REPLAT OF PART OF KINKAID PARK

"Replat of KINKAID PARK"
FINAL PLAT SHEET 1 OF 1

RE: SUB 2003-71 - One-Step Final Replat of Kinkaid Park Addition

CASE NUMBER: SUB 2003-71 -- REPLAT OF KINKAID PARK ADDITION

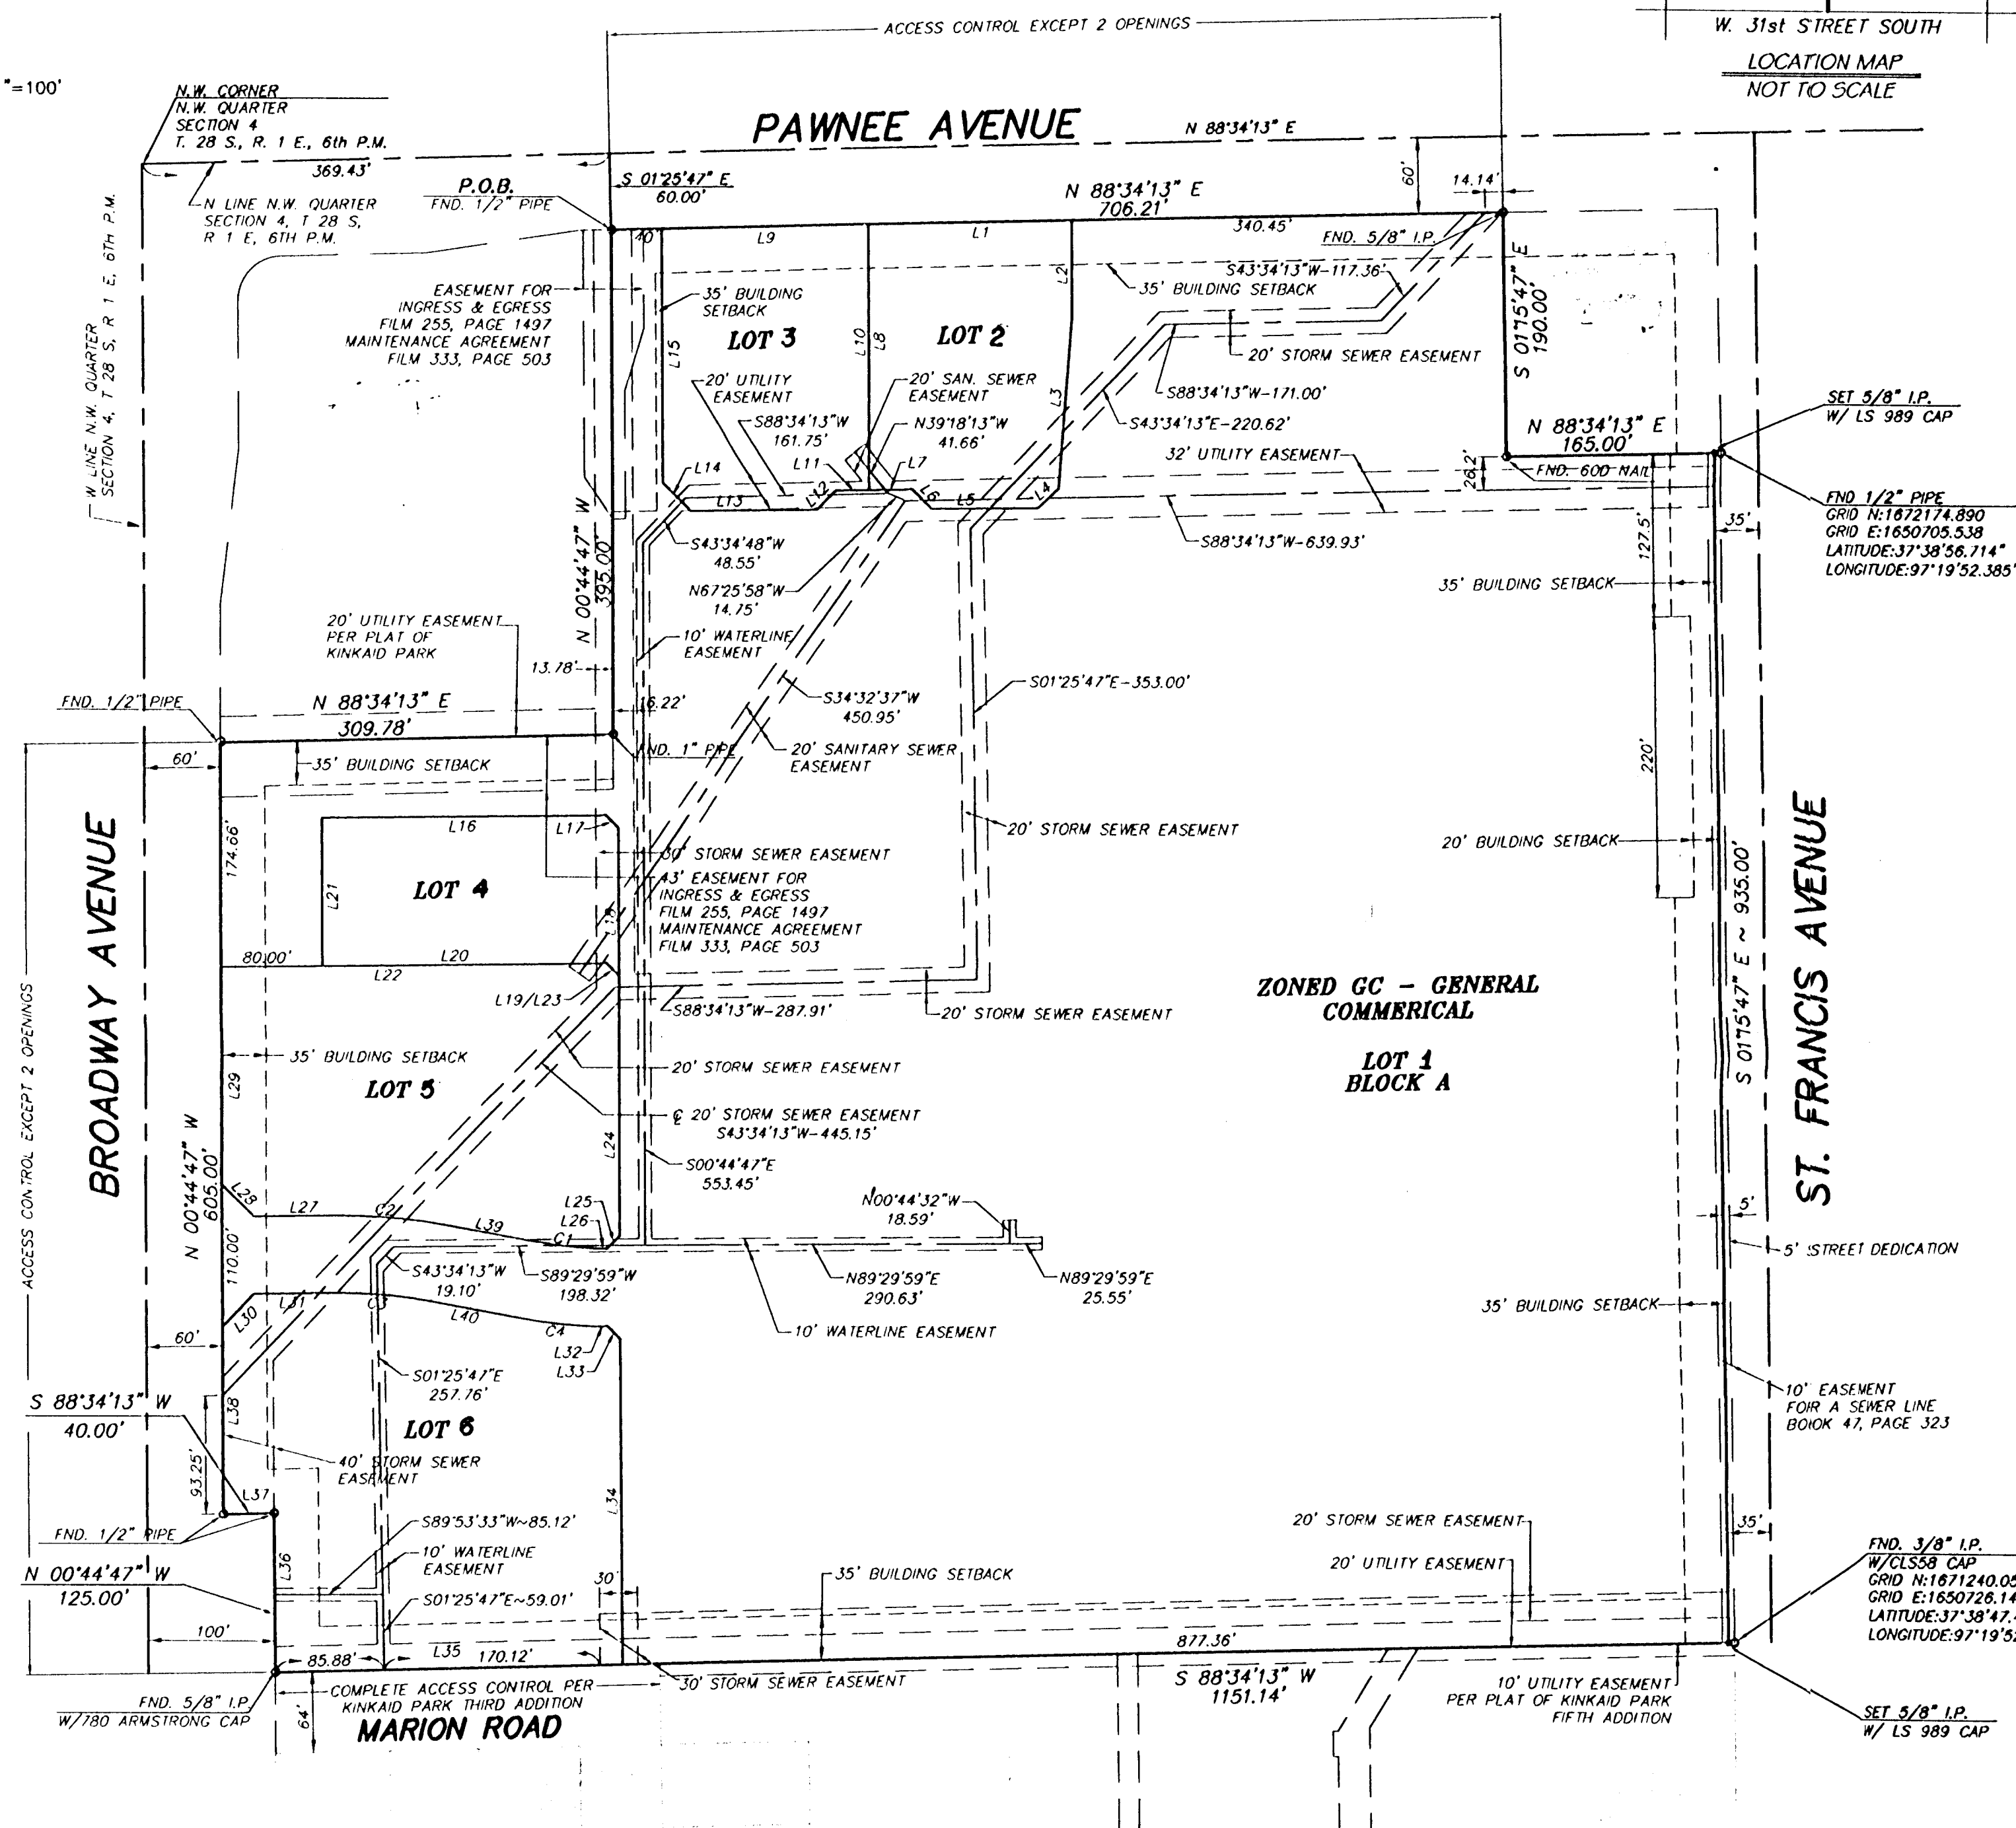
- A. City water services are available to serve the site. The applicant shall guarantee the extension of sanitary sewer to serve the lots being platted. Utility easements for water services need to be platted.

- C. A guarantee for the sewer abandonment will be required.
- D. The 10-ft sewer easement needs to be increased to 20 feet and extended to serve Lot 2C.

- J. County Surveying has requested a central angle (delta) with curve data.
-  K. The 20' portion of building setback along the east side of Lot 2A needs to be located.

- N. County Surveying has requested a bearing on internal lot lines.
- O. County Surveying has advised that the storm sewer easement along the south line of Lot 2A needs to be located. (20' north of south line)

- P. County Surveying has advised that the 10' sanitary sewer easement running southwest-northeast needs to be located.
- Q. County Surveying has advised that interior bearings need basis shown since some are plat and some are SPCS.

- R. The lot lines need to be solid lines.
- S. In accordance with the CUP amendment, a cross-lot circulation agreement is needed to assure internal vehicular movement between the lots.

- T. Traffic Engineering has requested additional right-of-way along St. Francis. The Subdivision Regulations require a 35-ft half-street right-of-way for a commercial street.

- U. The lots shall be renumbered as 1 through 6, Block A.
- V. A note shall be placed on the final plat, indicating that this Addition is subject to the conditions of to the Kinkaid Park Commercial CUP (CUP 2003-19, DP-43 Amendment #3).

- DD. Marion Rd. which abuts the plat to the south, shall be designated on the plat along with its right-of-way width.
- EE. The Applicant is reminded that a platting binder is required with the final plat. Approval of this plat will be subject to submittal of this binder and any relevant conditions found by such a review.
